Access Compliance Report

Public Rights-of-Way

Intersection ID: 21016	Main Street: COVEDALE_DR	Cross Street: WISHING_WELL_LN	Location: NW
ADA ID: 04AA058D0BC3	Ramp Type: PerpDiag	Initial Pass/Fail: Fail	Overall Compliance: No
Severity Score: 1.25			
Codes/Mitigation Info/Possible Solution		Field Measurements/Component Compliance

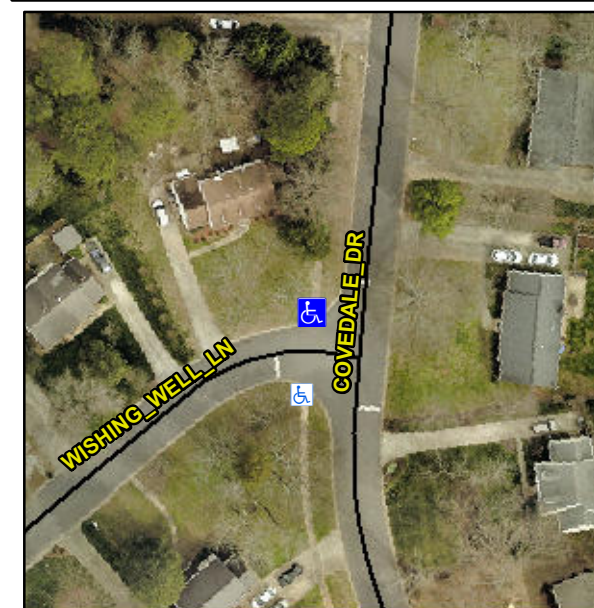
Remove & Replace Curb Ramp With Two New Directional Ramps or Equivalent.

Not Found, R304.5.3
